CERTIFICATE OF APPROPRIATENESS

Applicant: Phil Arnett for 2315 Union Street, LLC, owner

Proposal: Alteration – Porch- Revision

Recommendation: Denial - does not satisfy criteria 1, 4, 5, 7, and 9

COLUMN CONDITION
ORIGINAL REMOVED COLUMN

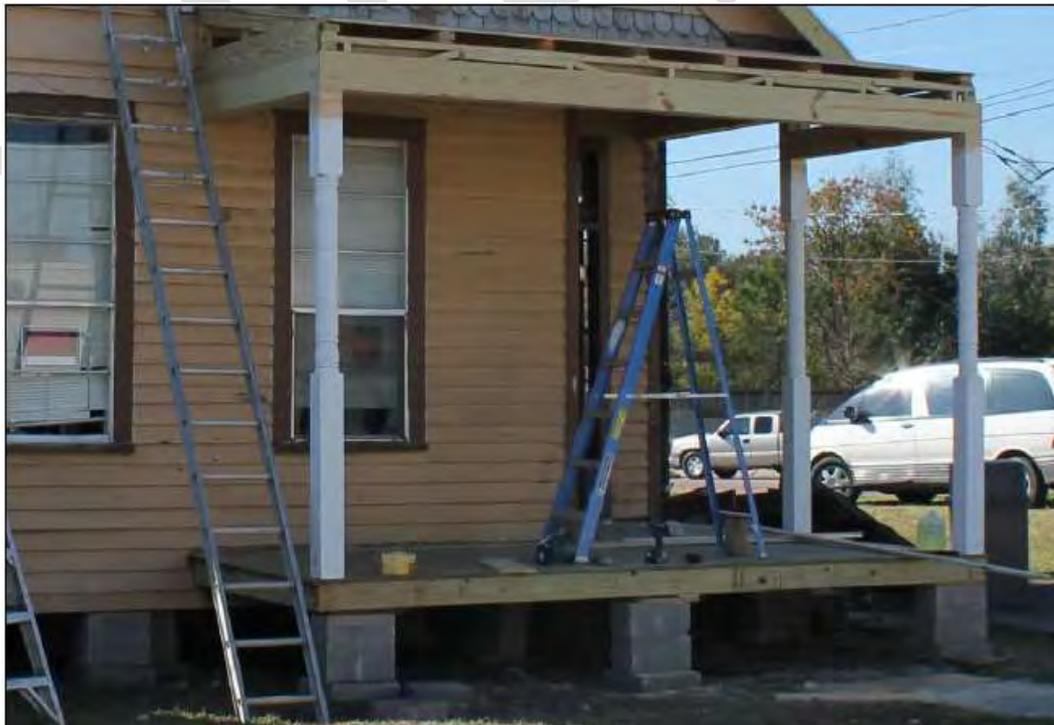
- (1) The proposed activity must retain and preserve the historical character of the property;
The removal of the original wood turned column and the installation of the 4 new wood turned columns that do not match the original style and significantly alter the character of the porch.

- (4) The proposed activity must preserve the distinguishing qualities or character of the building, structure, object or site and its environment;
The replacement of the original column results in the loss of significant historic material that is a distinguishing character of the historic residence.

- (5) The proposed activity must maintain or replicate distinctive stylistic exterior features or examples of skilled craftsmanship that characterize the building, structure, object or site;
The replacement of the original wood turned column with new turned columns that do not replicate the style of the original column results in the loss of historic material that is a distinctive feature that contribute to the character of the residence.

- (7) The proposed replacement of missing exterior features, if any, should be based on an accurate duplication of features, substantiated by available historical, physical or pictorial evidence, where that evidence is available, rather than on conjectural designs or the availability of different architectural elements from other structures;
The existing turned columns are not a duplication of the original removed wood turned column. The removed turned column was determined to be original based on pictorial evidence. Due to the pictorial evidence and the single remaining column any new columns should be a duplication of the original column.

COLUMN CONDITION

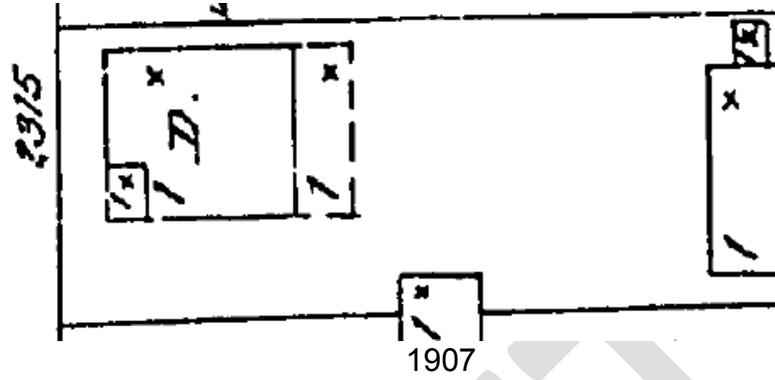
- (9) The proposed design for any exterior alterations or addition must not destroy significant historical, architectural or cultural material and must be compatible with the size, scale, material and character of the property and the area in which it is located;
The removal of the original historic wood turned column that is a defining feature of the historic residence result in the loss of significant historic material and alters the character of the historic residence.
